### **2.2.1 Project/Site Supplemental Information**

The Erosion Prevention and Sediment Control (EPSC) Plans for the Initial, Interim, and Final Conditions (Drawings C-026 through C-037) have been revised to remove all proposed EPSC measures from the three (3) identified streams and to place additional controls adjacent to the streams. The revised EPSC plans accompany this supplemental information.

WASTEWATER TREATMENT PLANT EXPANSION  
BLEDSOE COUNTY CORRECTIONAL COMPLEX  
PIKEVILLE, BLEDSOE COUNTY, TENNESSEE SBC PROJECT 142/013-01-2013-06

DRAWING NO.  
C-036.1

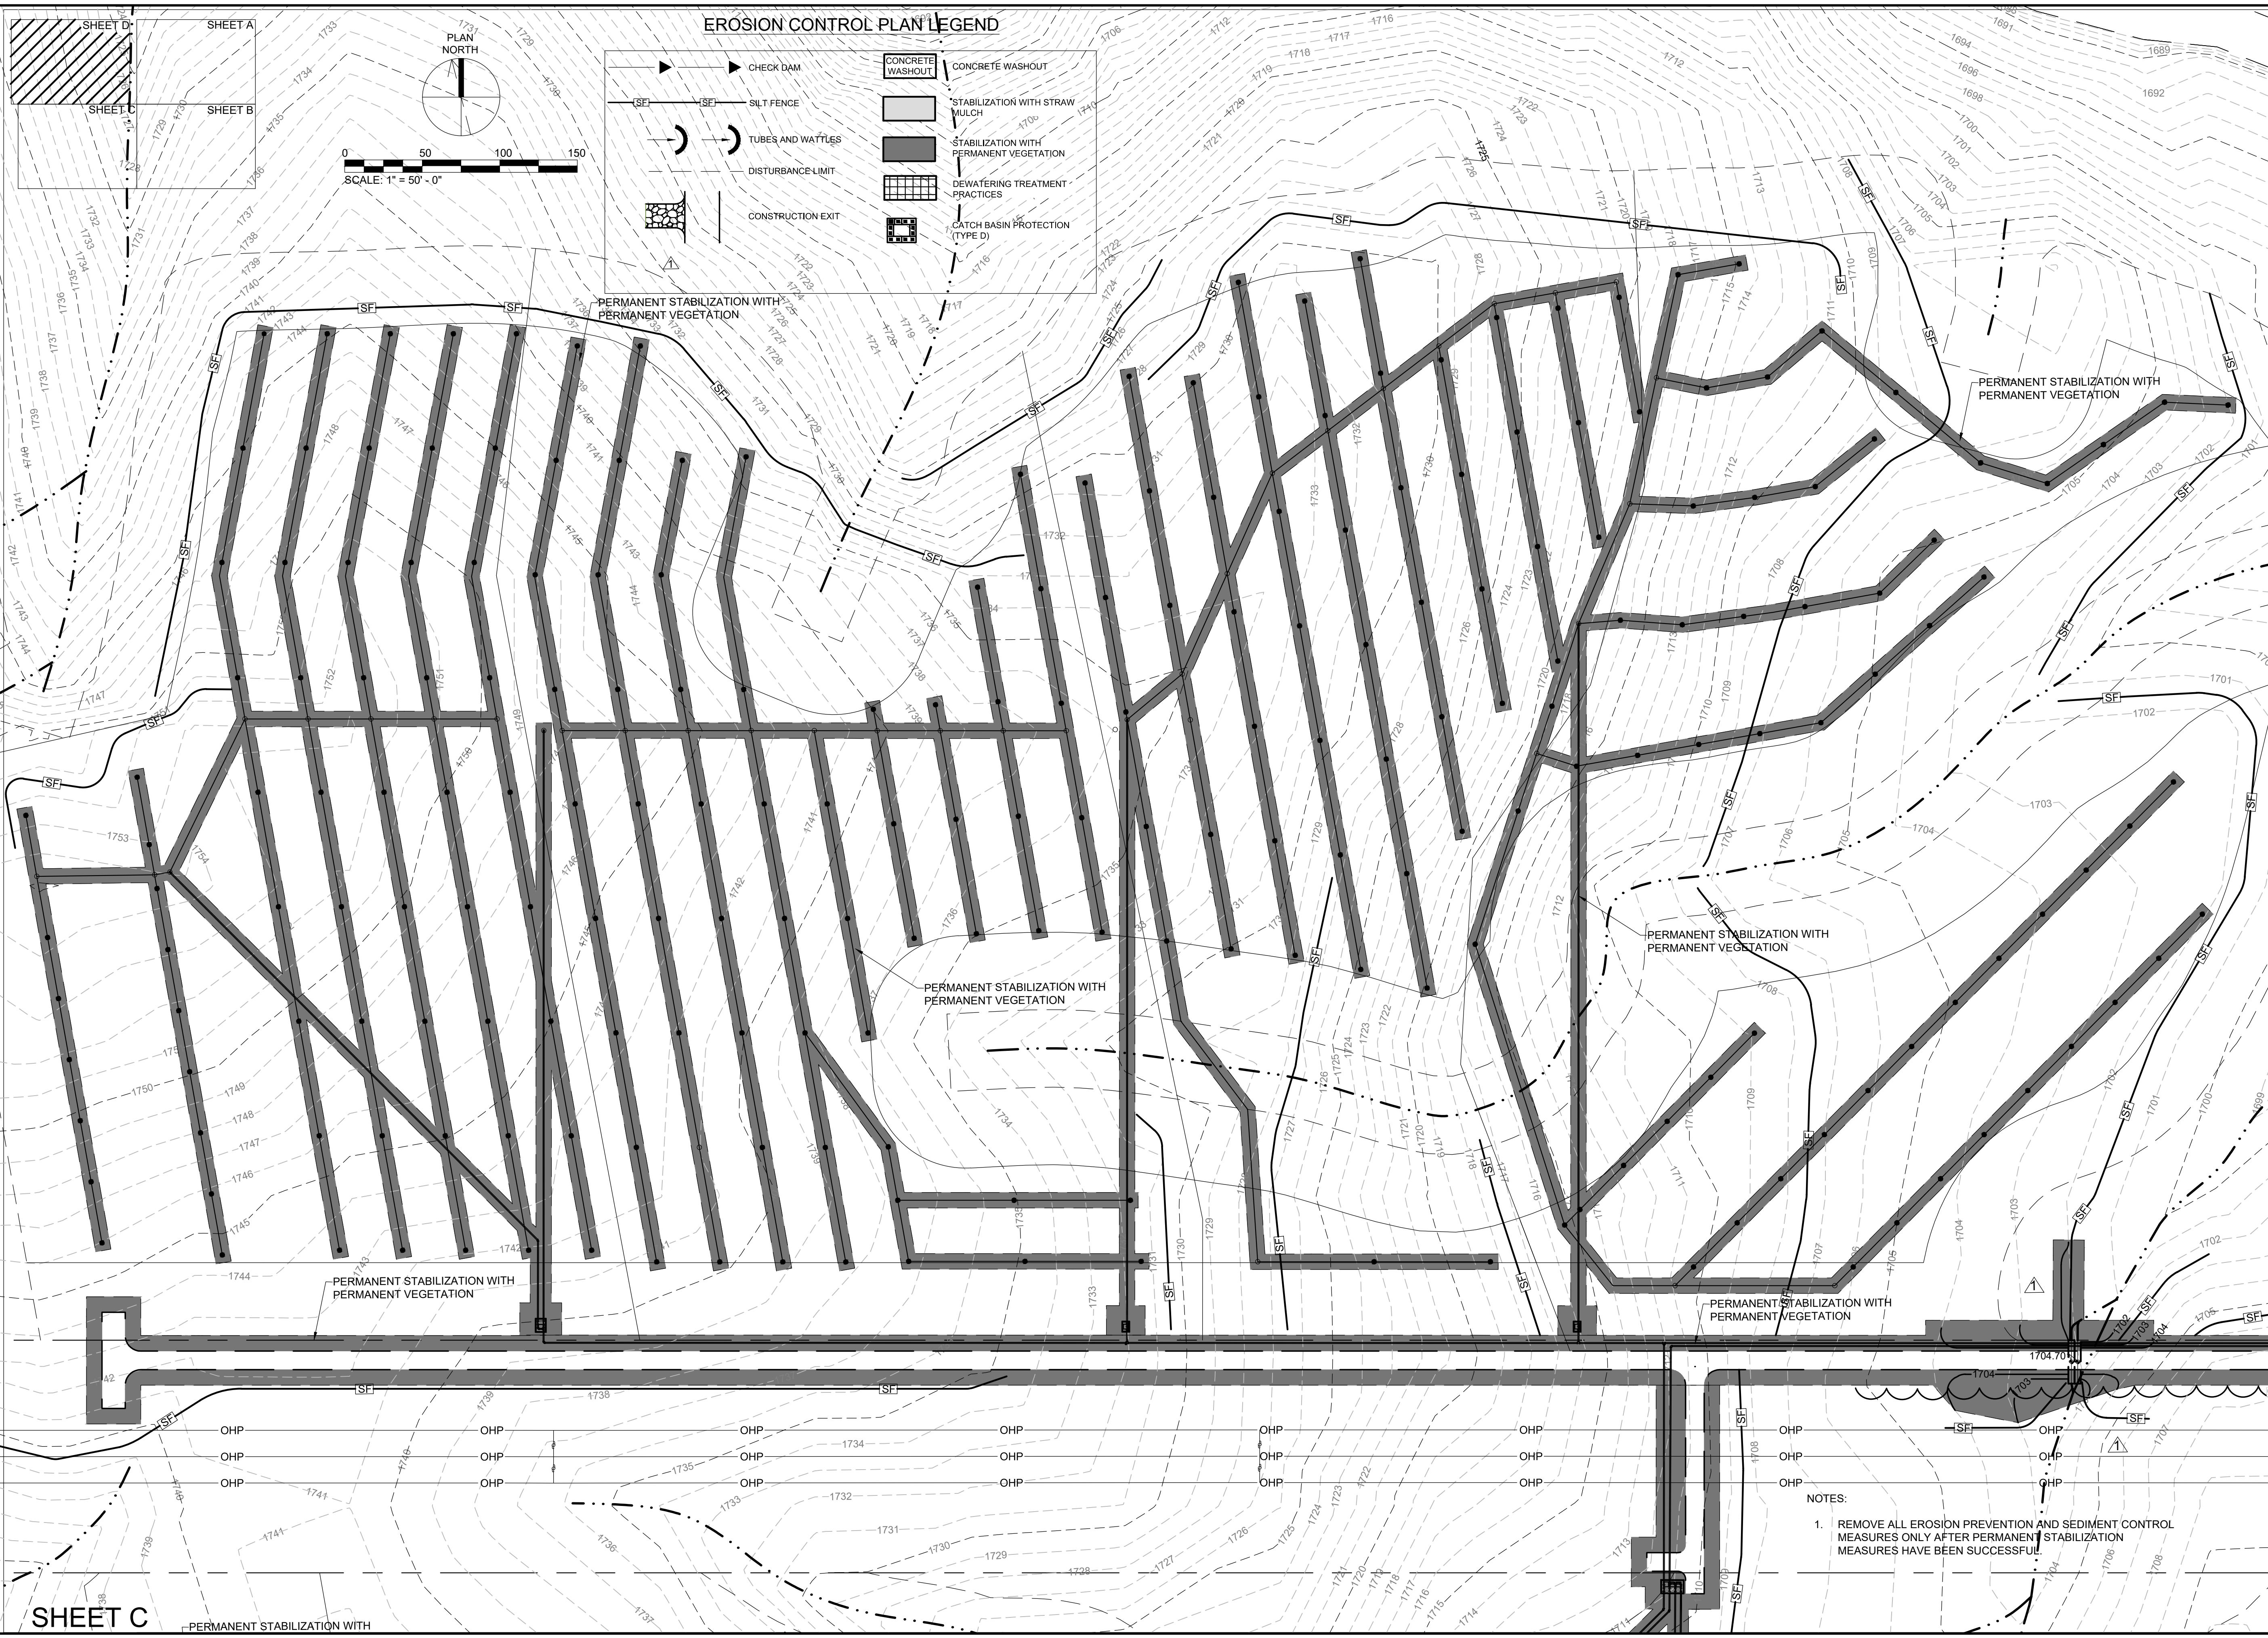
| DESIGN |         | REVISIONS |  |
|--------|---------|-----------|--|
| JRH    | 7/25/19 | 1         | REMOVED EPSC MEASURES FROM DESIGNATED STREAMS. ADDED EPSC MEASURES ADJACENT. |
| NH     |         |           | REVISED LEGEND   |

JOB NO. N16003  
 ISSUE DATE November 30, 2018  
 SCALE 1" = 50' - 0"  
 DRAWING NO. C-037.1

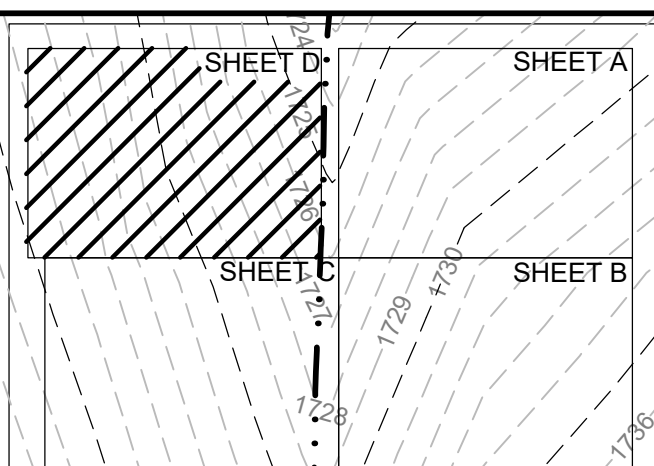
| REVISIONS |   | DATE    | BY | APPD |
|-----------|---|---------|----|------|
| 1         | REMOVED EPSC MEASURES FROM DESIGNATED STREAMS, ADDED EPSC MEASURES ADJACENT | 7/25/19 | NH | NH   |
|           | REVISED LEGEND  |         |    |      |
